Product Change Notification

Item	Current	New	
LED driver	Renesas (P/N: ISL97678IRZ)	Rohm (P/N: BD93941EFV)

PCN No.: 1042 Page: 1/1

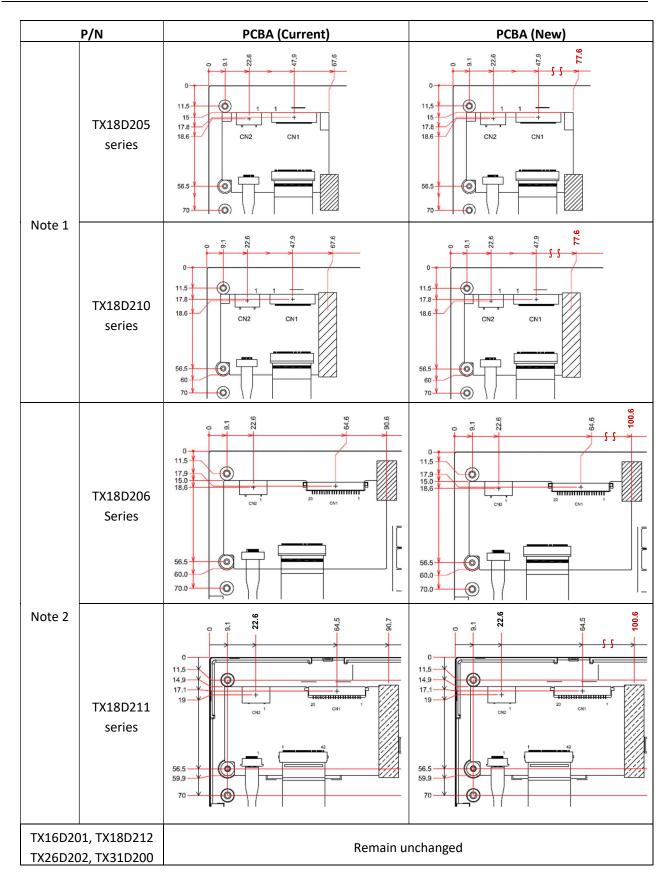
Product optical performance and other electronic specification remains unchanged, PCBA dimension change are detailed in Note-1 & Note-2.
